STATE OF NORTH CAROLINA
DEPARTMENT OF TRANSPORTATION

Subject: Modification Request for the Individual Section 404 Permit, Individual Water Quality Certification, and Tar-Pamilico Buffer Authorization for the Rocky Mount Northern Connector, from SR 1604 (Hunter Hill Road) to US 301, Nash County, TIP No. R-2823, Debit \$570 from WBS 34509.1.1.

In an application dated December 17, 2008, the North Carolina Department of Transportation (NCDOT) submitted an Individual Permit application for the Subject project. This application requested authorization for impacts to jurisdictional features based upon a final design prior to an additional public meeting presenting the final design, held on October 28, 2008. Based upon comments from the meeting and subsequent inquiries from the public concerning the traffic flow from Station -L- 27+45 to Station 65+55, the roadway was re-designed to include directional crossovers and four bulb U-turns to provide additional left-turn traffic flow along Woodruff Road. The redesign will result in unavoidable impacts to Waters of the U.S. Revised permit drawings, buffer drawings and roadway plans are included with this modification request.

PROJECT REFERENCE NO.		SHEET NO.	
R-2823		7	
RW SHEET NO.			
ROADWAY DESIGN ENGINEER		HYDRAULICS ENGINEER	
REVISED 06/11/09			
PERMIT DRAWING			
SHEET 15		OF 68

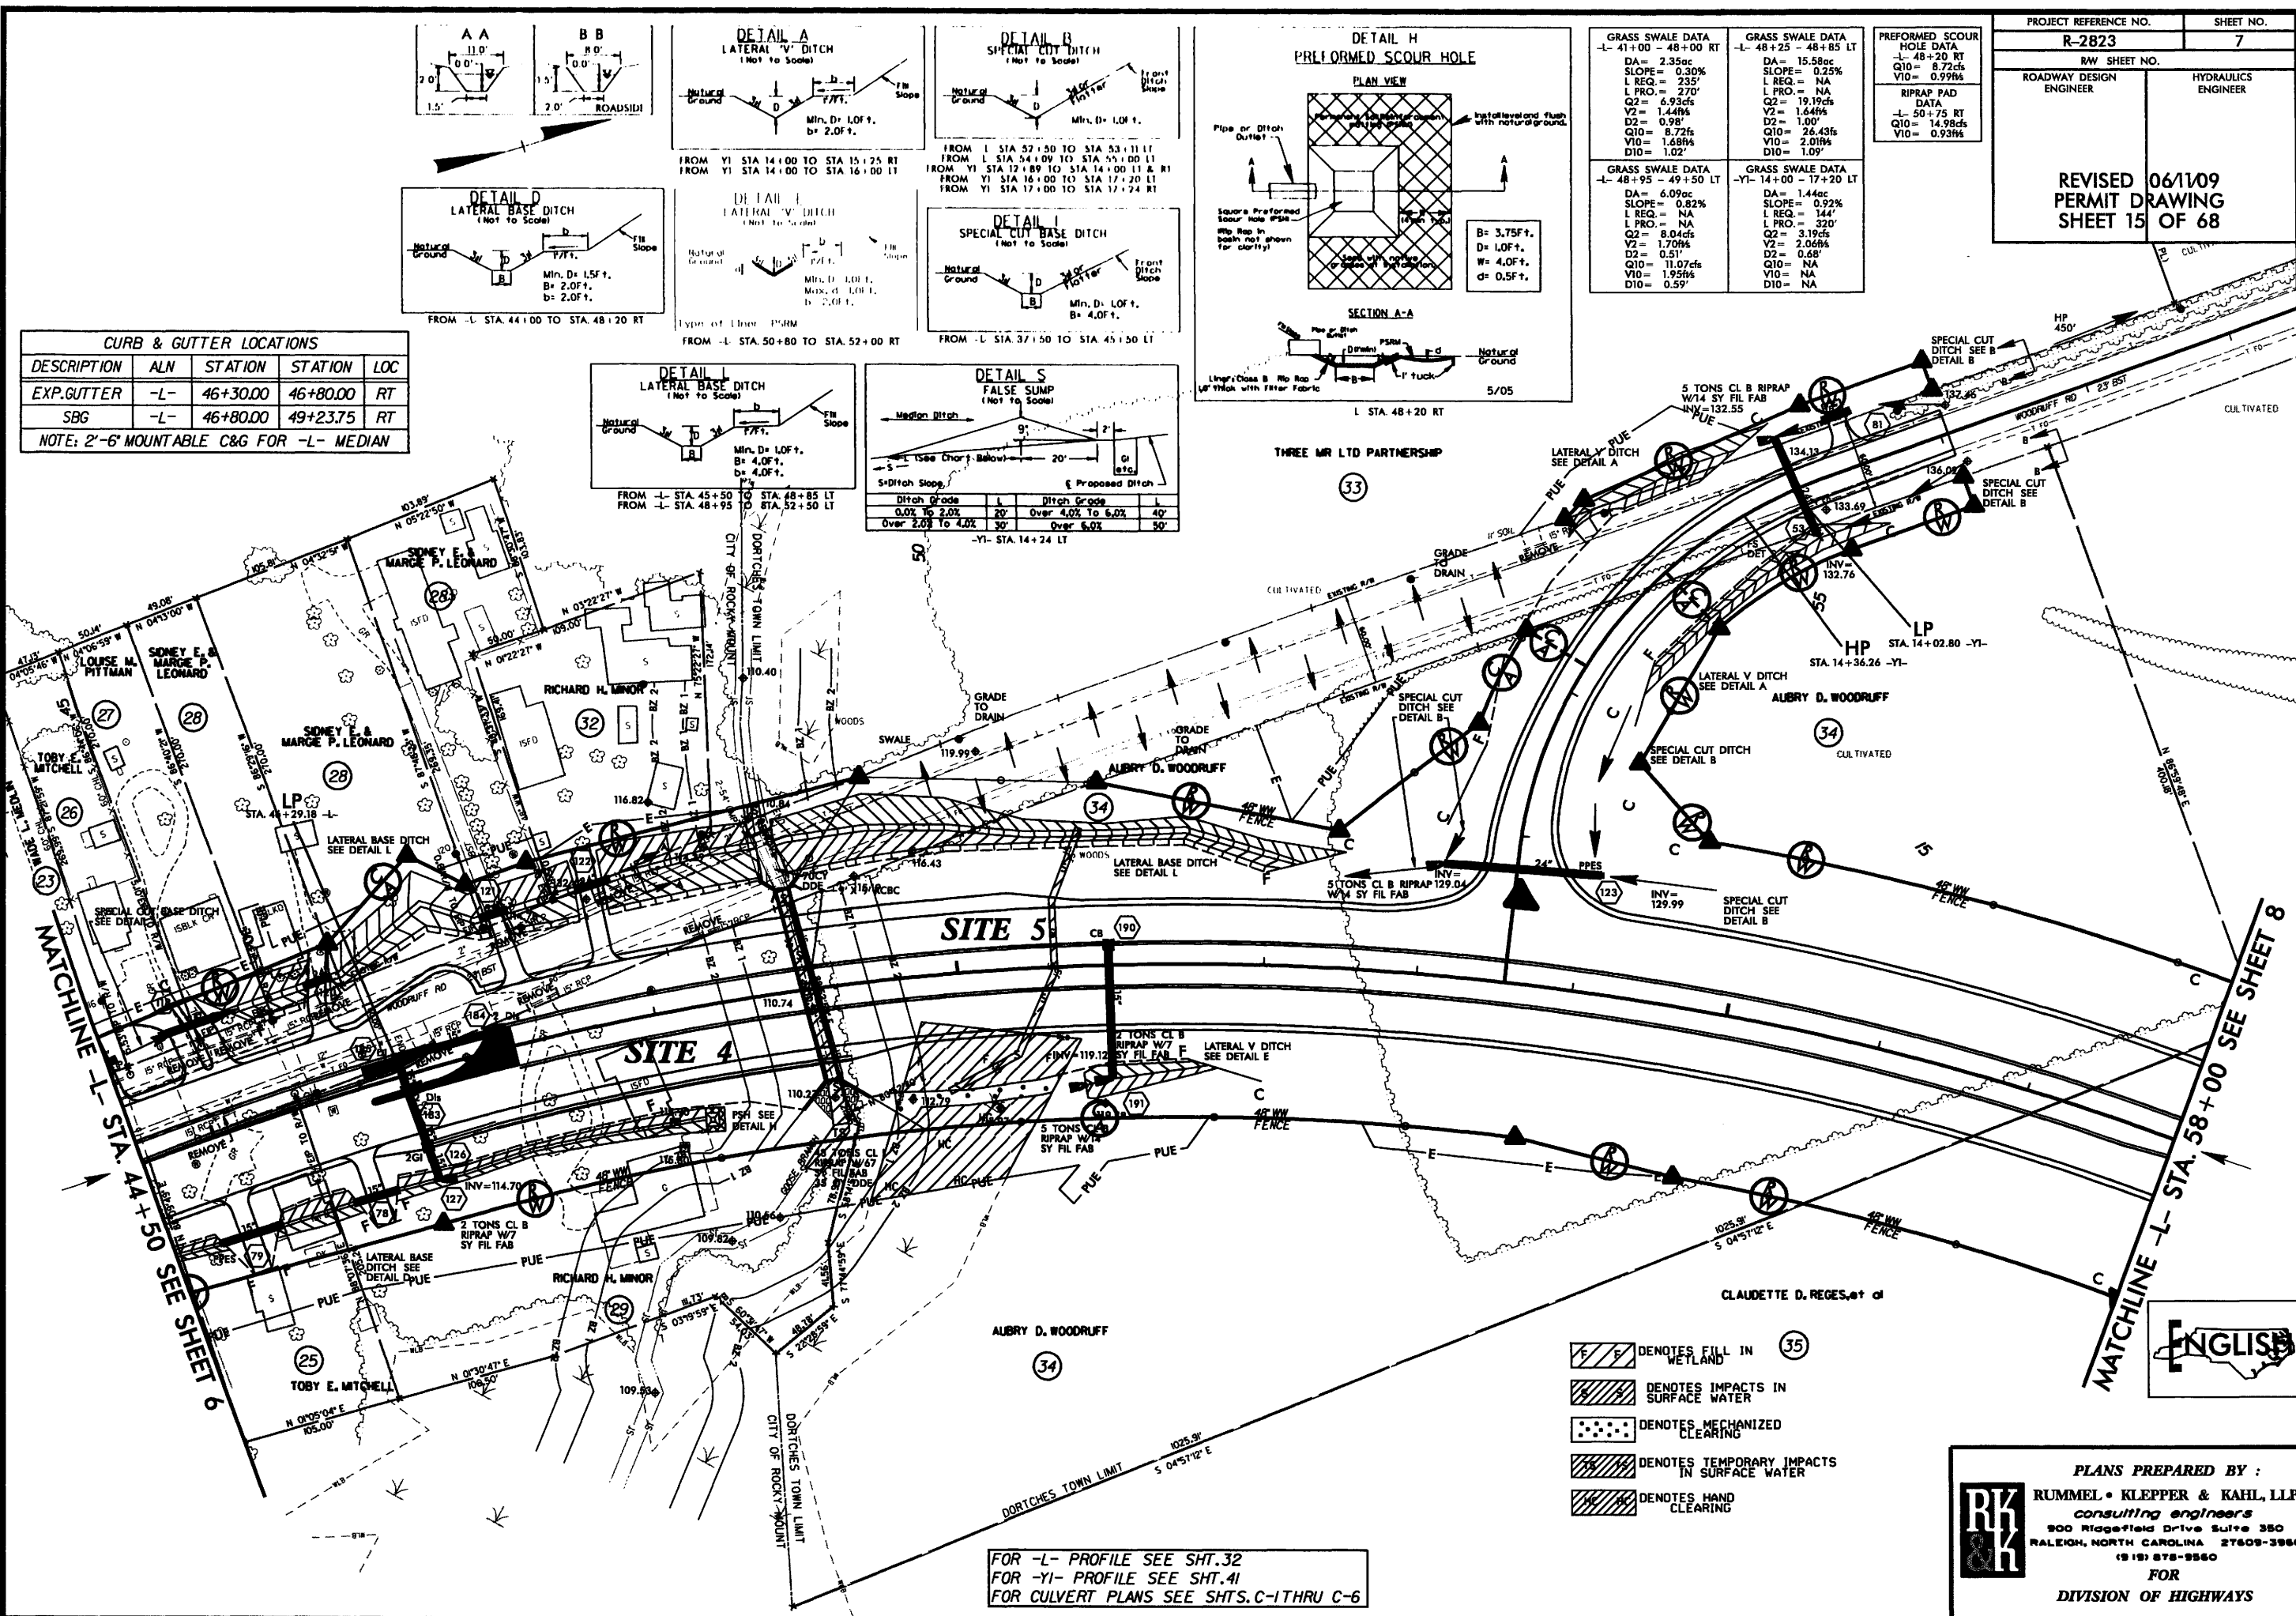
The revised drawings (Permit Sheets 14 and 15 of 68 and Buffer Sheets 15 and 16 of 56) indicate that impacts at Site 4 will change due to aerial utility lines. The sheets have also been revised due to a new bulb which does not have an impact on the environmental features. A summary of the original and revised impacts is provided in the following table.

The revised drawings (Permit Sheets 14 and 15 of 68 and Buffer Sheets 15 and 16 of 56) indicate that impacts at Site 5 will change due to aerial utility lines. The sheets have also been revised due to a new bulb which does not have an impact on the environmental features. A summary of the original and revised impacts at Site 5 is provided in the following table.

Impact Description	Dec. 17, 2008 Impact	Revised Impact	Impact Change
Perm. Surface Water Impacts	0.04 Ac (158 LF)	0.04 Ac (158 LF)	None
Temp. Surface Water Impacts	0.01 Ac (54 LF)	0.01 Ac (54 LF)	None
Wetlands in Buffer Zone 1	41 sq ft	168 sq ft	+127 sq ft
Wetlands in Buffer Zone 2	574 sq ft	1,712 sq ft	+1,138 sq ft
Mitigable Buffer Zone 1	10,527 sq ft	11,823 sq ft	+1,296 sq ft
Mitigable Buffer Zone 2	6,437 sq ft	7,647 sq ft	+1,210 sq ft

Impact Description	Dec. 17, 2008 Impact	Revised Impact	Impact Change
Fill in Wetlands	0.08 Ac	0.08 Ac	None
Mech. Clearing in Wetlands	0.03 Ac	0.03 Ac	None
Hand Clearing in Wetlands	0	0.11 Ac	+0.11 Ac
Perm. Surface Water Impacts	0.02 Ac (210 LF)	0.02 Ac (210 LF)	None

REVISED 06/1/09
PERMIT DRAWING
SHEET 17 OF 68

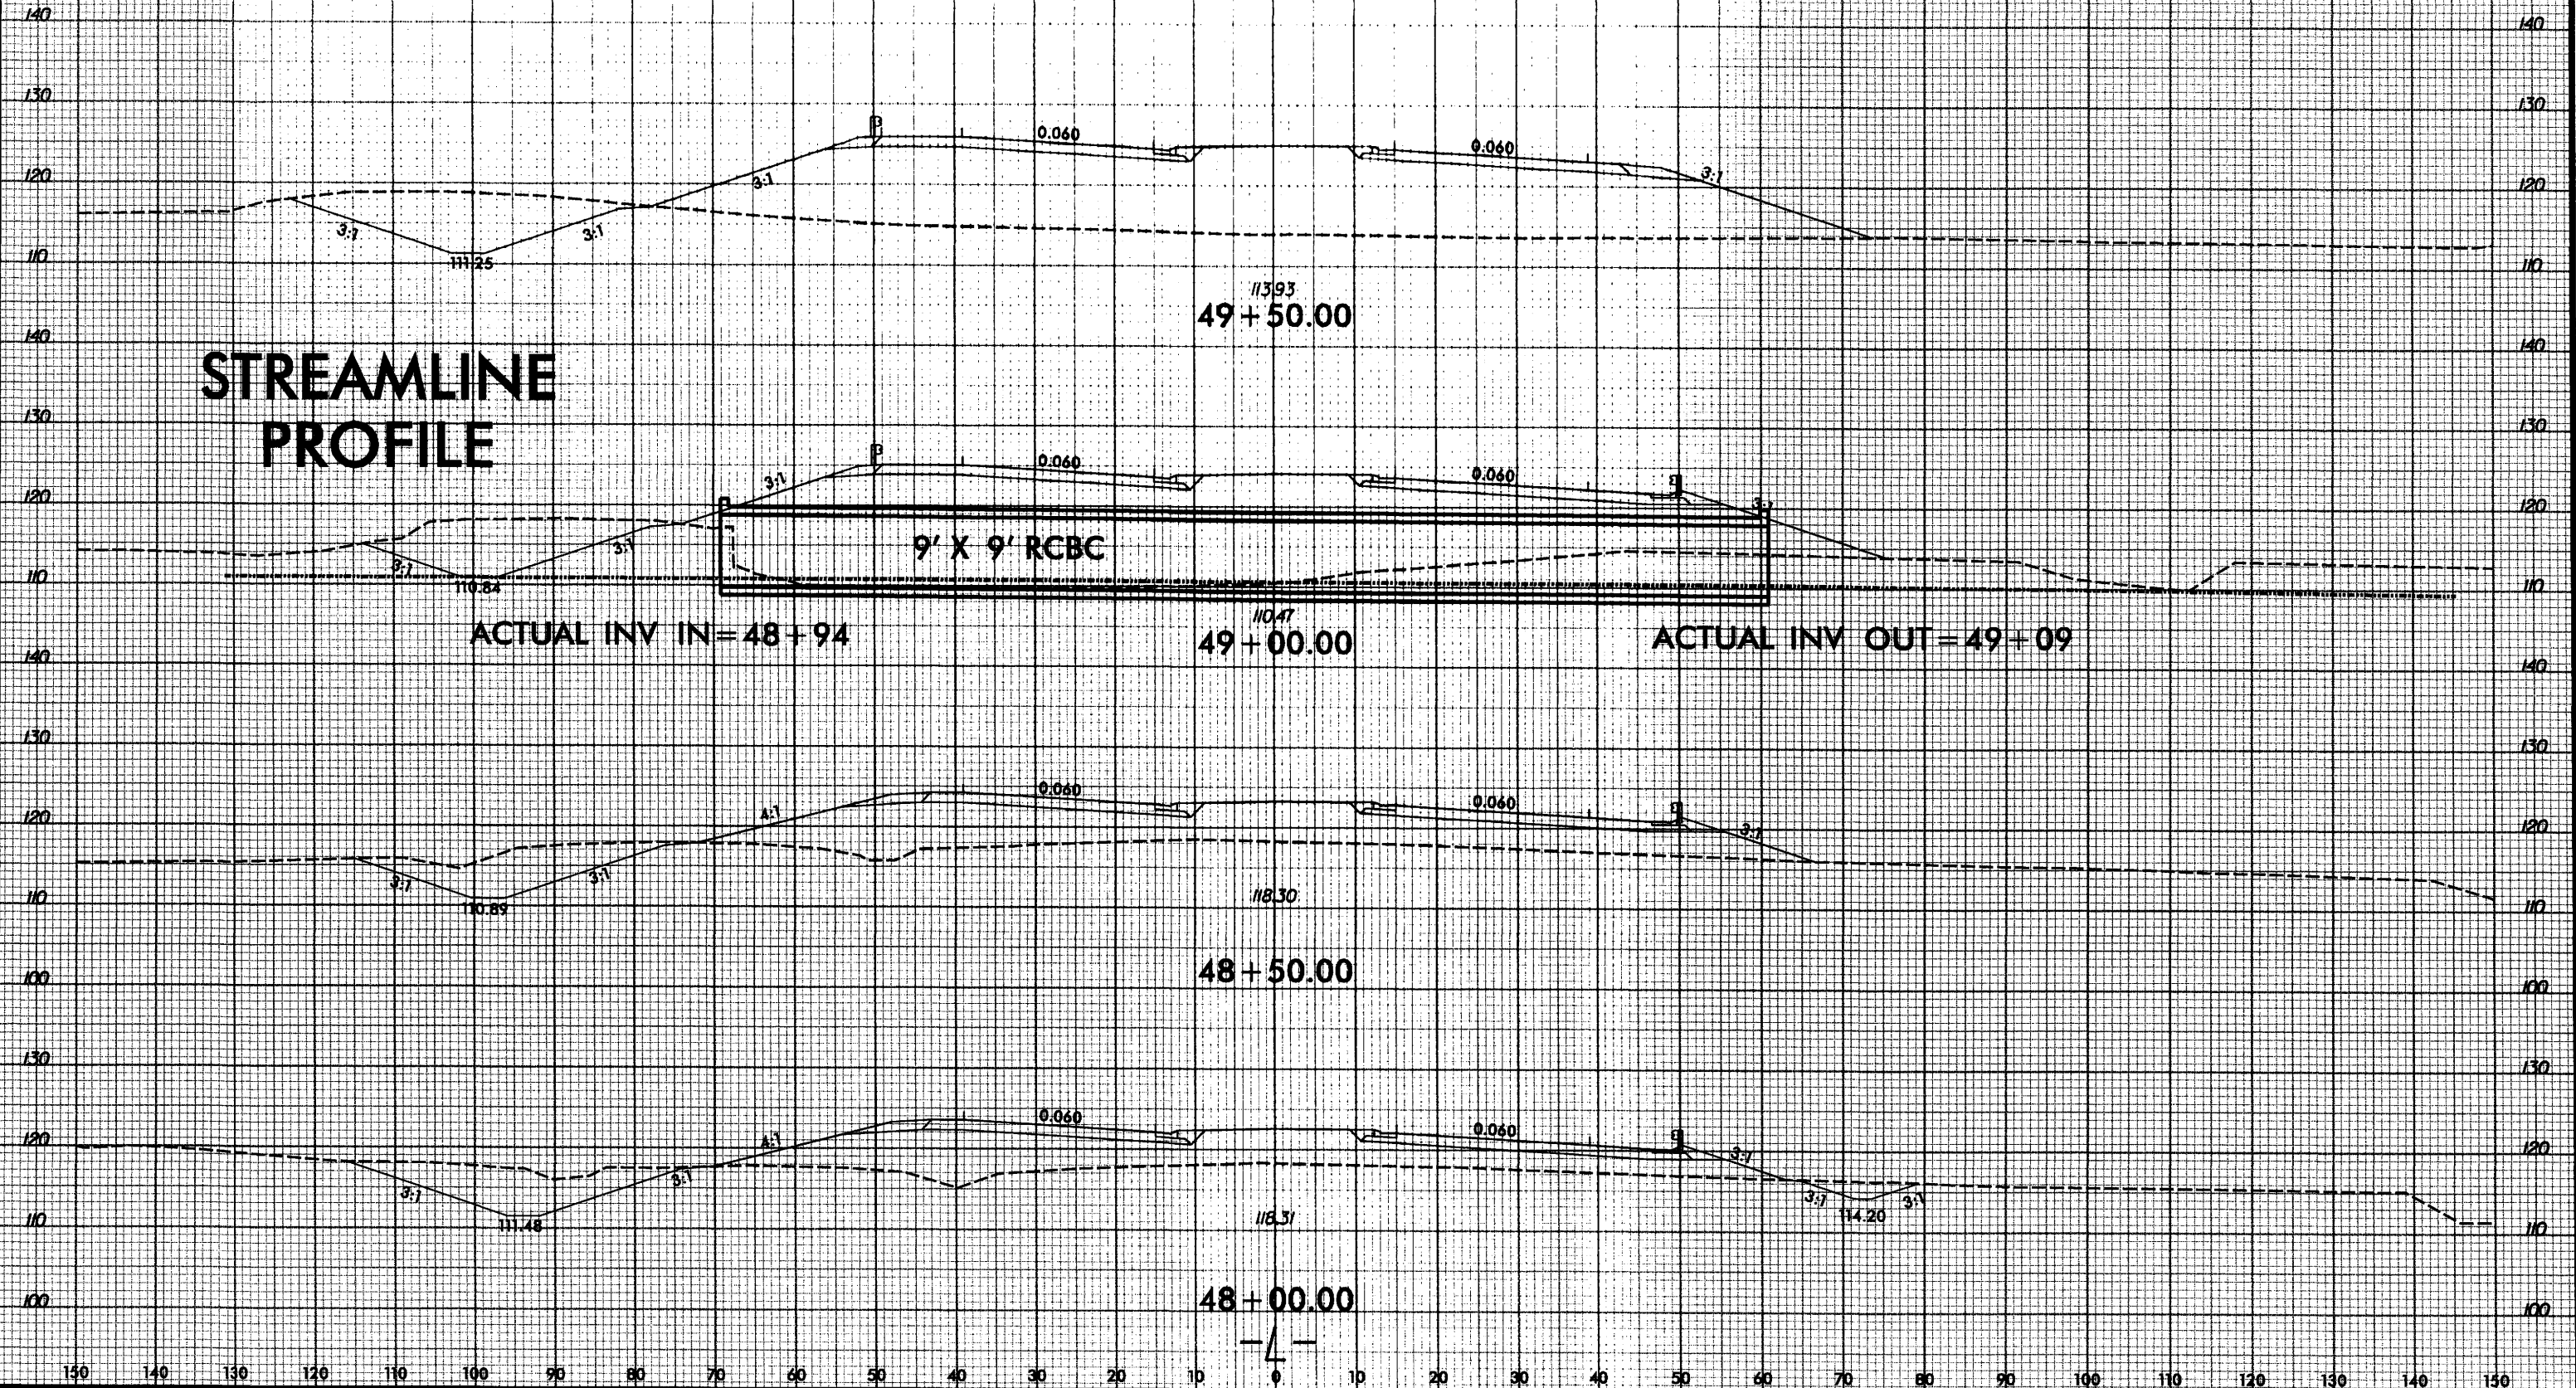
Revised profile and cross section permit sheets 16-18 of 68 (buffer sheets 17-19 of 56) are enclosed.

Revised cross section permit sheets 16-18 of 68 (buffer sheets 17-19 of 56) are enclosed.
